**SB-10045239-3321**

Technical Information Bulletin

44-024

Updated Throttle Pedal for Engine Brake and Throttle Pedal Position Complaints

**Replace part S21-1011
with part S21-1025**

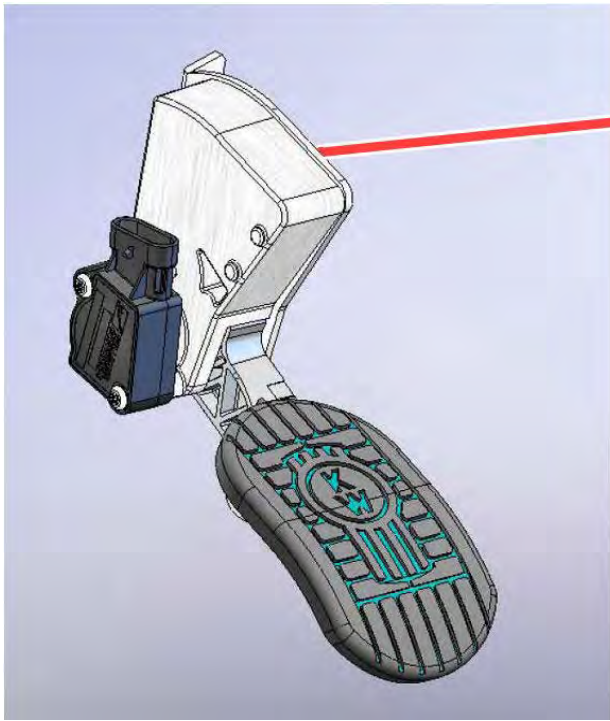
Throttle pedal position return range too narrow to engage engine brake; engine brake not engaging

If a customer comes into your dealership and demonstrates the condition above, inspect the throttle pedal and replace original equipment part number S21-1011 with current production part number S21-1025 as described in the Procedure below.

1. Verify with the customer or through testing that the failure (Jake inoperative) and cause (throttle pedal position) are consistent with this bulletin Condition and Chassis Affected.
2. Inspect the throttle pedal bracket to identify the installed part number.
3. If part number S21-1011 is installed, replace this with part S21-1025.

Note: Do not replace the sensor only. The sensor is calibrated to the pedal.
